SUNDRY NOTICES AND REPORTS ON WELLS

AXI Apache "L" No. 3

Re: Permanent Abandonment

CONDITIONS OF APPROVAL

PROPOSED P&F 1121'DOIR

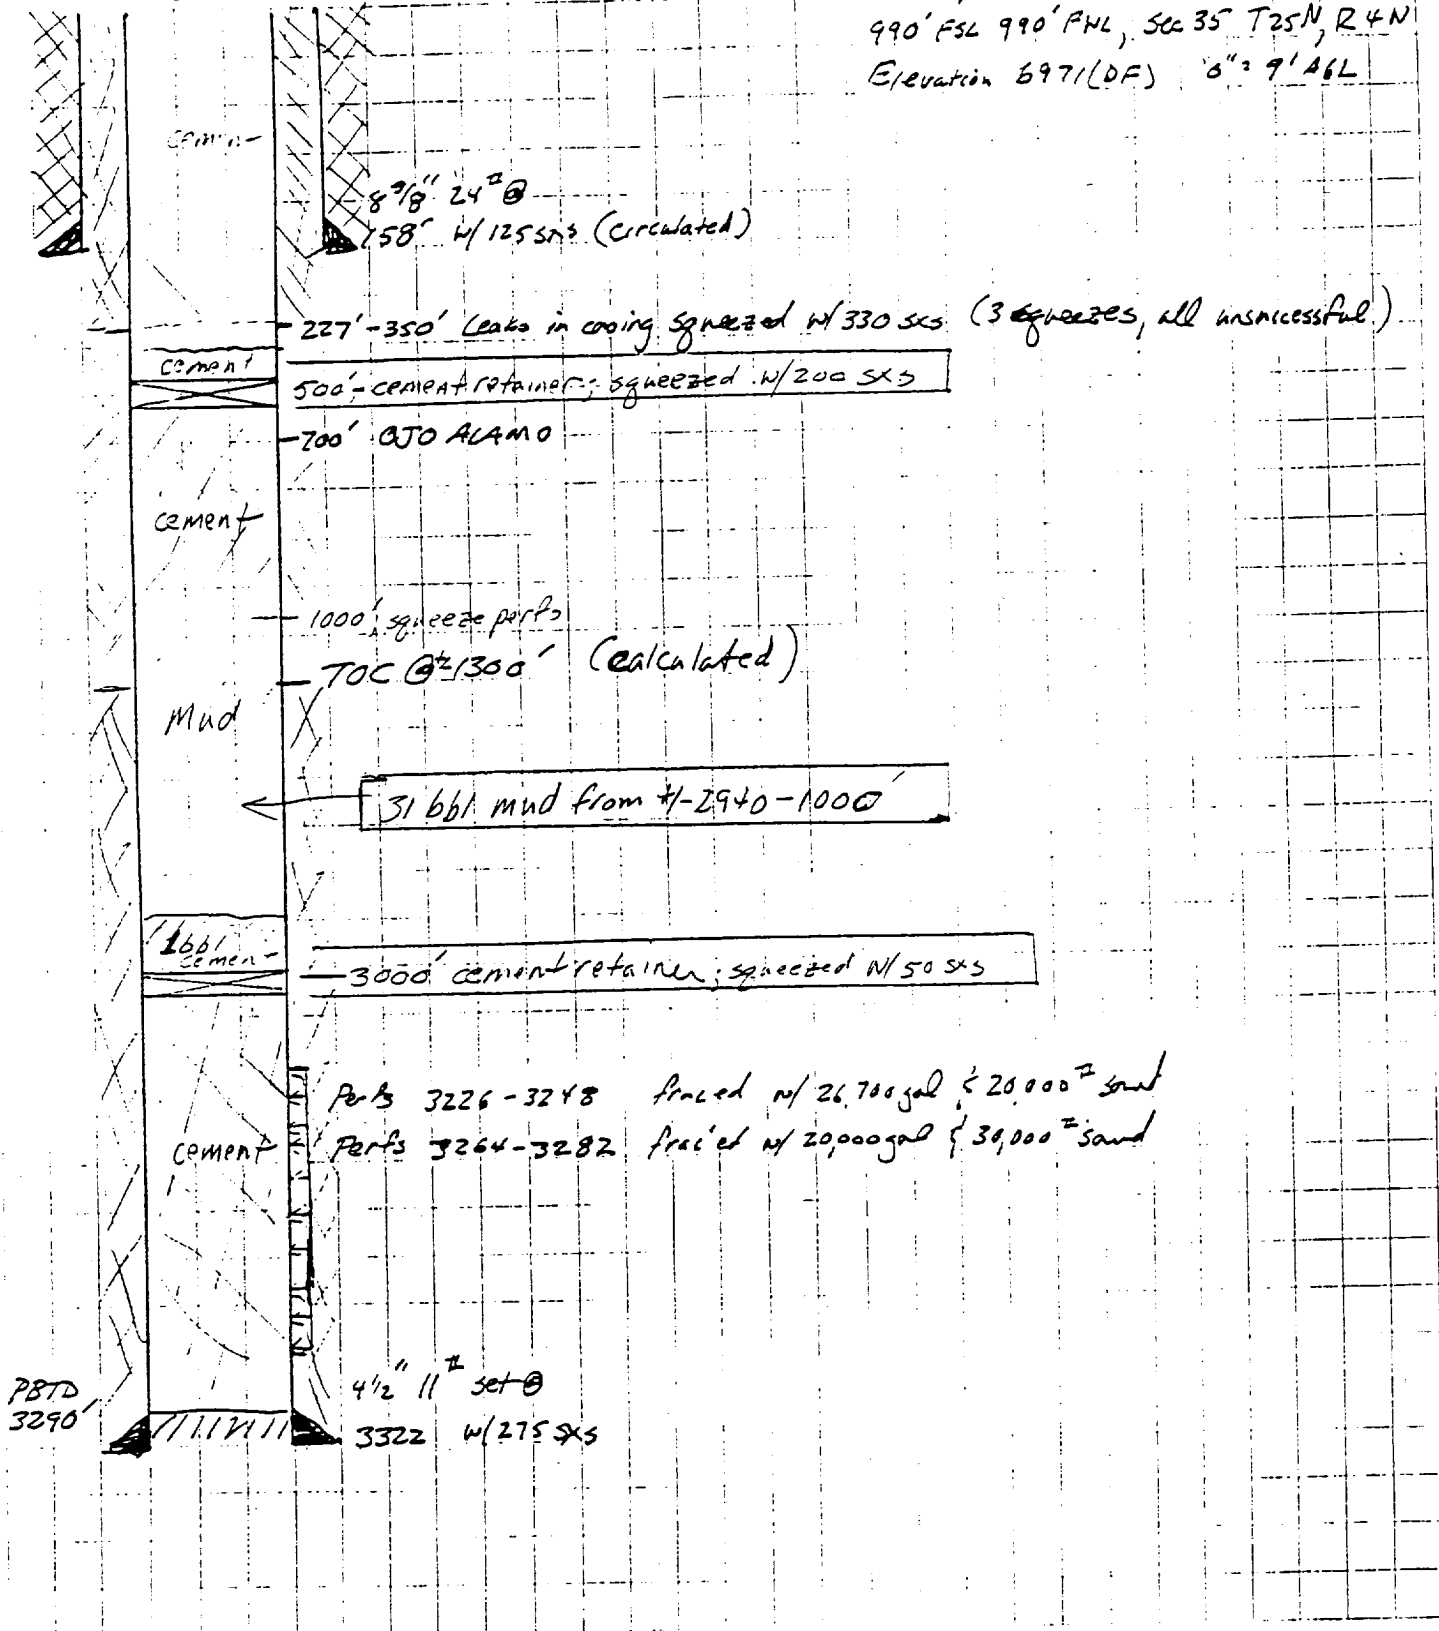
Add a plug from 2940 - 2435' (Ojo Alamo 2890' - 2485')
